Verification Report for

Project : TEIL Biomass Grid Supply Power Project, Deoband,
Uttar Pradesh

UCR Project ID : 328

CAR 1:

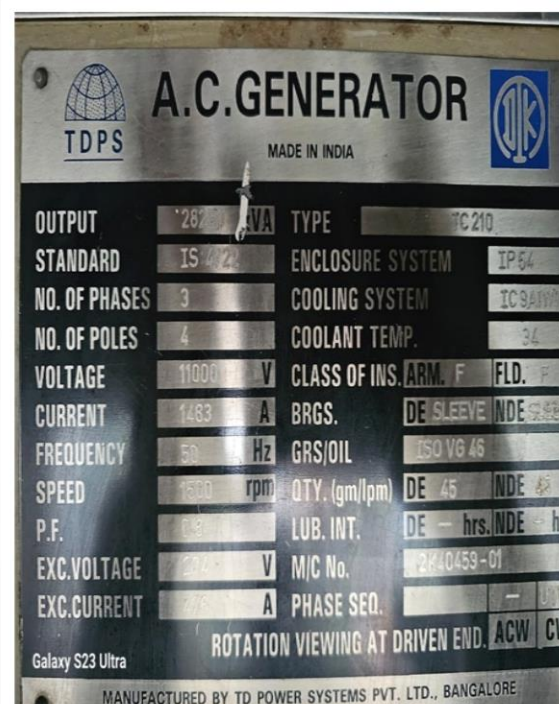
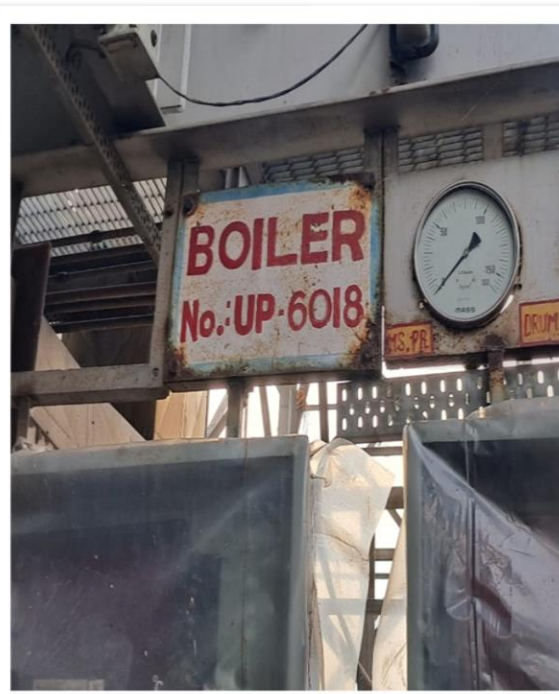
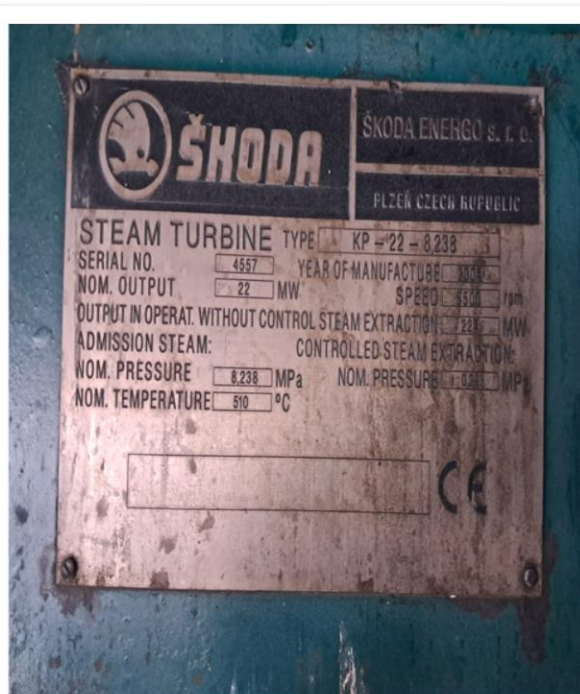
The Net quantity of electricity supplied to the grid as per JMR & Invoice is not matching with the ER statement.

The correction has been made in the ER sheet and accordingly Monitoring Report (V02) has been released after incorporating the related corrections.

Verified Monitoring Report (V02) for correction and found to be matching as per requirement.

Corrective Action Request CAR-1 is closed.
